ProVent 200 IV (1316868S01)  
ProVent IV Element (LC5001/2X)

We would like to inform you about a new design change to the ProVent 200 System. The new ProVent 200 is known as the **ProVent 200 IV**. The 'IV' is in reference to the new 'internal ventilation' characteristics of this new design.

ProVent 200 IV Conversion Instructions (LC5001/2X):

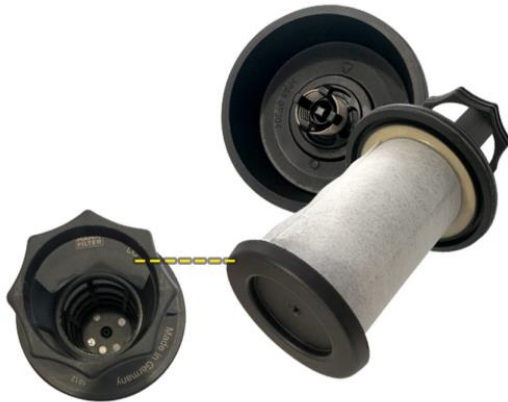
1. Inclusion of the new LC5001/2X element design which has an over pressurization valve integrated into it.
2. Revised inner lid design which has the over pressurization valve deleted.

- Installing the old style LC5001X element into the new IV system will eventually cause over pressurization of the crankcase if the element becomes blocked. This is because the system will no longer have an over pressurization valve. It is critical that the old LC5001X element is not used in the new IV system.
- Installing the new LC5001/2X (IV element) in a standard ProVent 200 which is not converted to the IV design is 100% safe to do. In this configuration the system will essentially have two over pressurization valves.

ProVent 200 IV Conversion Instructions.

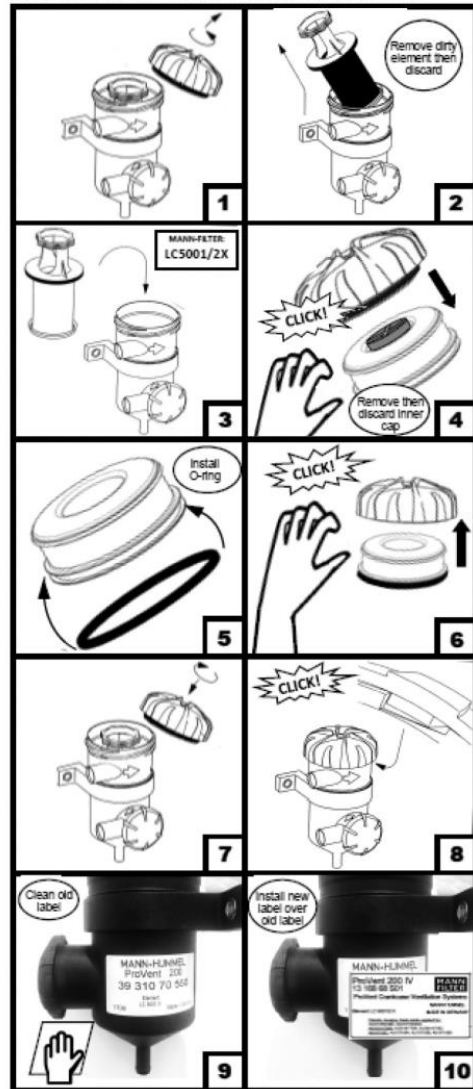
WARNING: Only install LC5001/2X after conversion completed.

**IMPORTANT: It is critical that the old LC5001X element is not used in the new IV system.**
